**Subject: Jericho Diamond Mine
Processed Kimberlite Containment Area
East and Southeast Dam – Reply to INAC – Nunavut Regional Office**

The following addresses technical questions raised in the letter from INAC – Nunavut Regional Office, dated November 14, 2005 regarding EBA's Jericho East and Southeast Dams Design Report and construction drawings and specification.

SUBJECT: **Stability Analysis of East and South Dams
Jericho Diamond Mine, Nunavut**

TO: Bill Horne
FROM: Gordon Zhang
SUBJECT: Thermal Analysis of East and South Dams
Jericho Diamond Mine, Nunavut

EAST DAM - TYPICAL SECTION

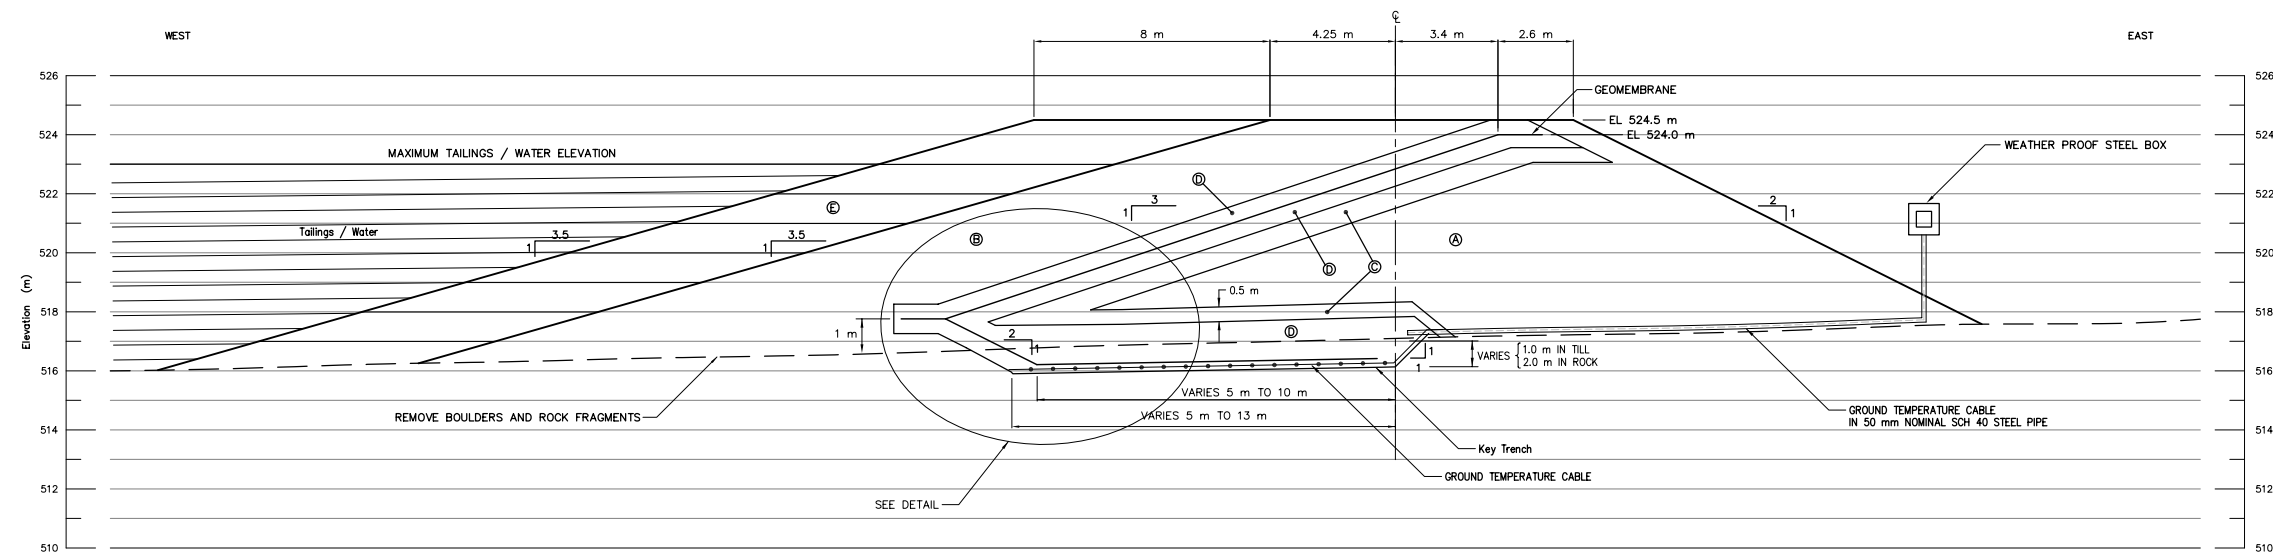
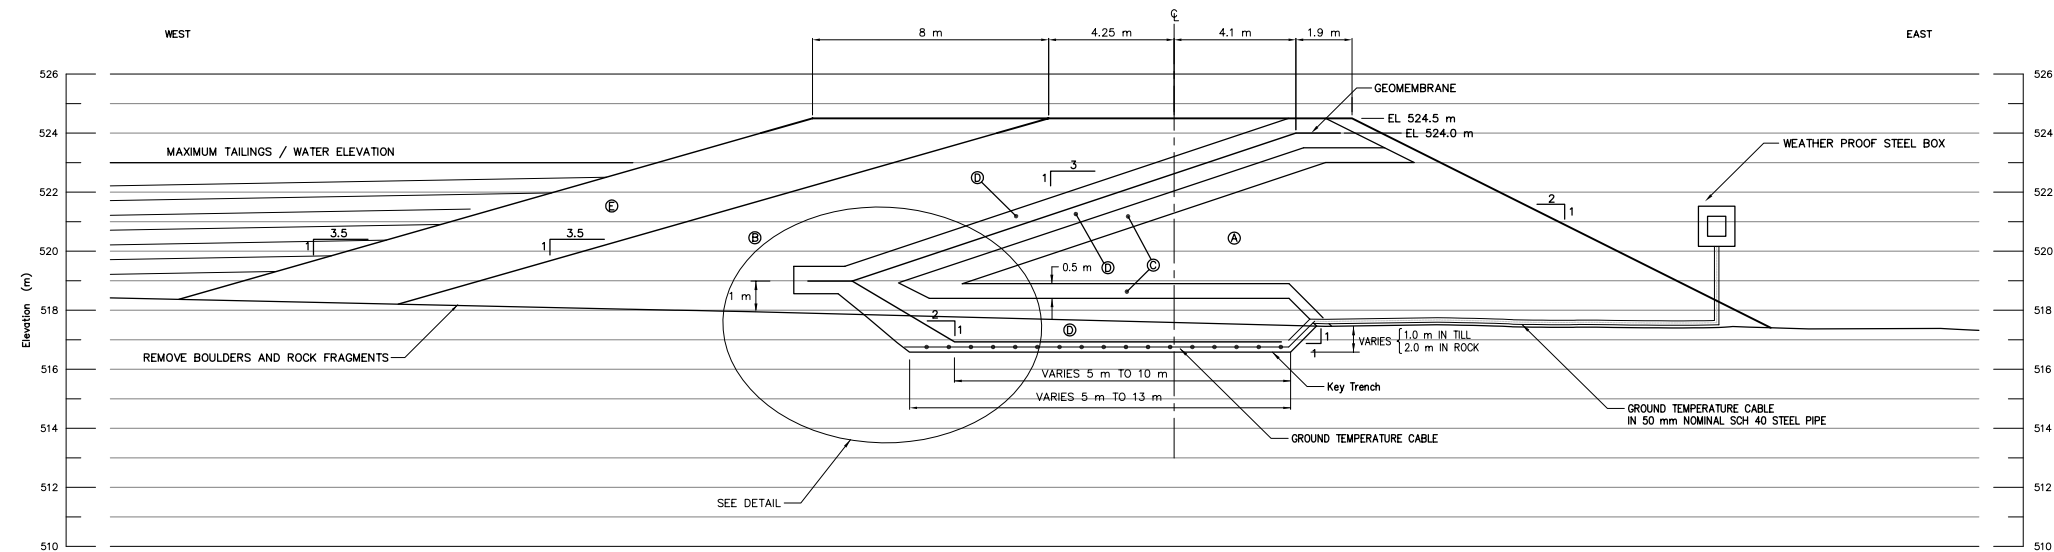
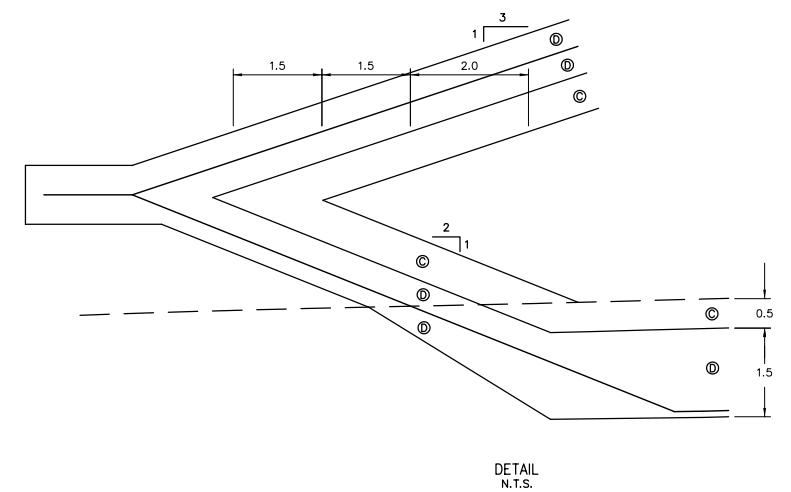
The “maximum operating water level” for the PKCA has been defined as elevation 523 m. The water level may rise above this level while flood waters are discharged and will also be higher due to waves and wave run-up. The “maximum water level” which includes waves and a temporary rise during flood routing has been defined as 524 m for the PKCA. The difference between the “maximum operating water level” and “maximum water level” is the freeboard. The top liner elevation of the dam has been increased to 524 m such that the water retention element in the dam is equal to the maximum water level. The dam crest will be 0.5 m higher than this to provide cover over the liner. The dam section is shown in the attached drawing ED – 4.

Revised drawings are attached. The drawing changes include an increase a crest elevation to 524.5 m, a top of liner elevation of 524 m, and a minimum thickness of rockfill above the frozen saturated fill of 3.5 m.
